SUBJECT: Forwards 90-day response to GL 97-04, "Assurance of Sufficient NPSH for ECC & Containment Heat Removal Pumps," 971007.

PG&E Letter DCL-98-002

Docket No. 50-275, OL-DPR-80
Docket No. 50-323, OL-DPR-82
Diablo Canyon Units 1 and 2
90-Day Response to NRC Generic Letter 97-04, "Assurance of Sufficient Net Positive Suction Head for Emergency Core Cooling and Containment Heat Removal Pumps"

**Containment Recirculation Sump - Unit 2
(Cross Section)**

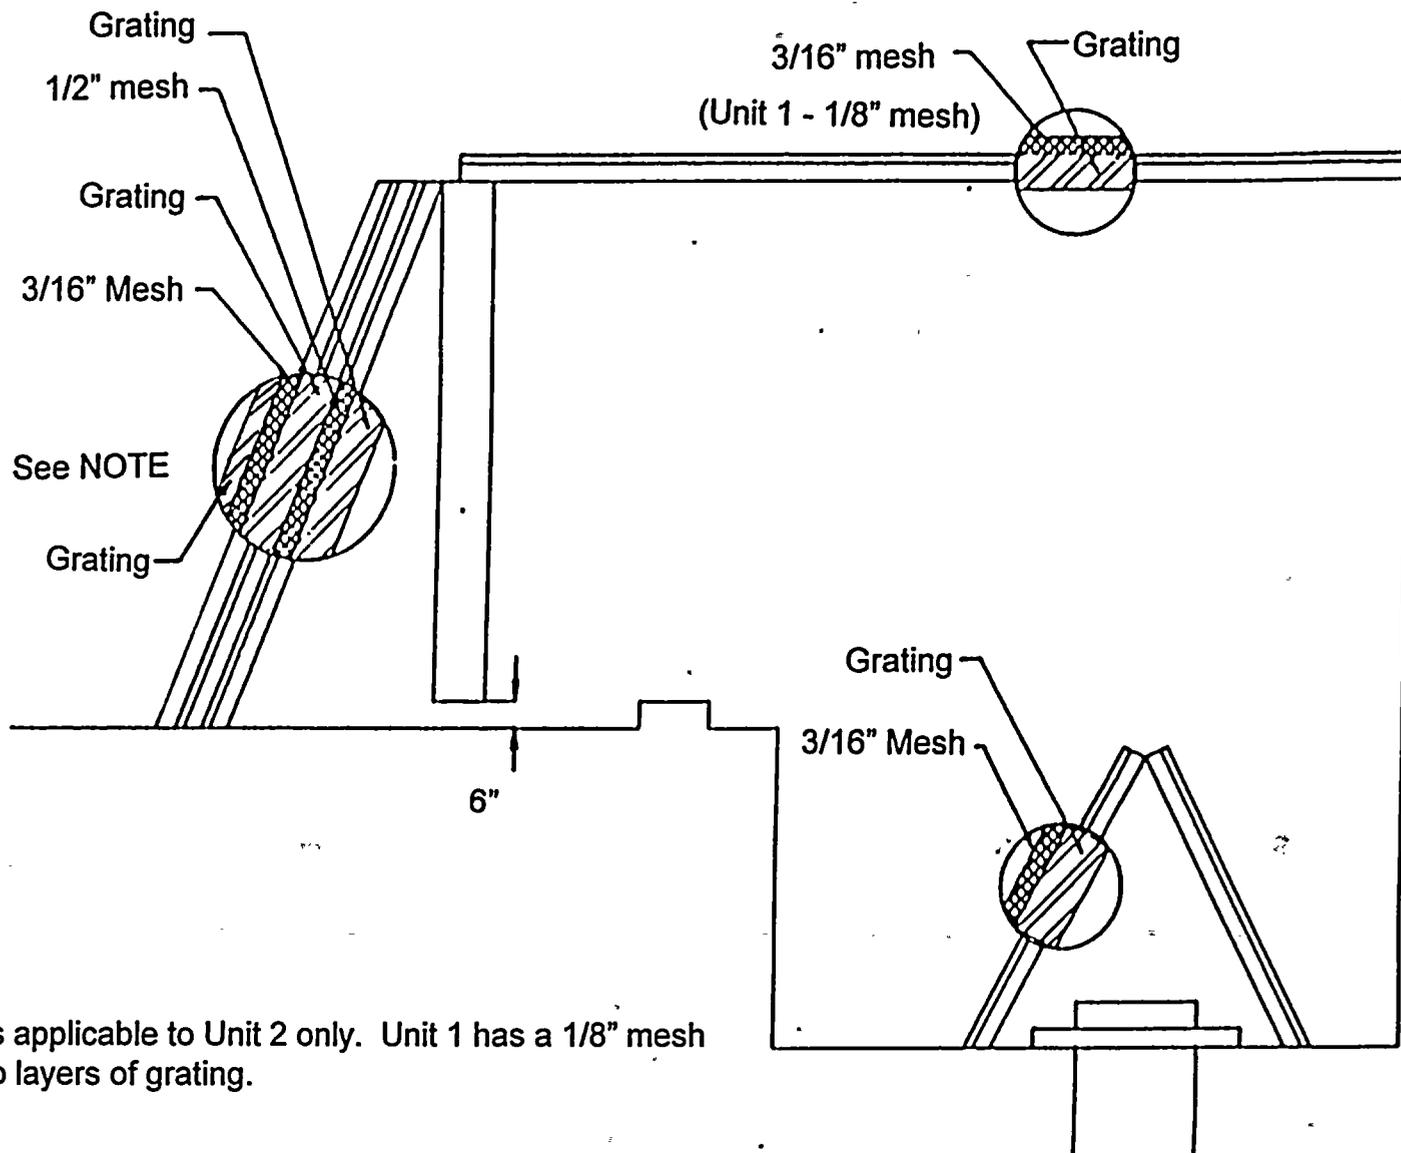
Each Unit has one recirculation sump that is located in the annulus area of the containment between the crane wall and the containment liner at the 91-foot elevation (see attached Figure). The floor of each sump is at the 88 foot elevation and is approximately 27 feet long and 7 feet wide. Two 14 inch diameter recirculation supply lines that supply separate RHRPs, are on opposite sides of the sump, and rise above the floor to further minimize the ingestion of debris. A lower debris screen, in the form of an inverted-V, is directly above the RHR recirculation supply lines and runs the length of the sump. This debris screen includes a 3/16 inch mesh screen. In the center of this inner screen is a triangular grating and 3/16 inch mesh screen, separating the two RHR recirculation lines.

At the 91 foot elevation, a baffle arrangement, consisting of a wall 5 feet high with a 6 inch high opening at floor level, and a 6 inch curb enclose the front of the sump to restrict the flow of debris into the sump. The Unit 1 sump outer screen has a 1/8 inch mesh screen. The Unit 2 outer sump screen has 3/16 inch mesh. The Unit 2 sump will be modified to match the Unit 1 sump during the next Unit 2 refueling outage. The outer screen

assembly is pitched at an angle of approximately 68 degrees towards the containment wall from the floor and rises to the 96 foot elevation. The total unobstructed area of the inclined outer screen is approximately 130 square feet.
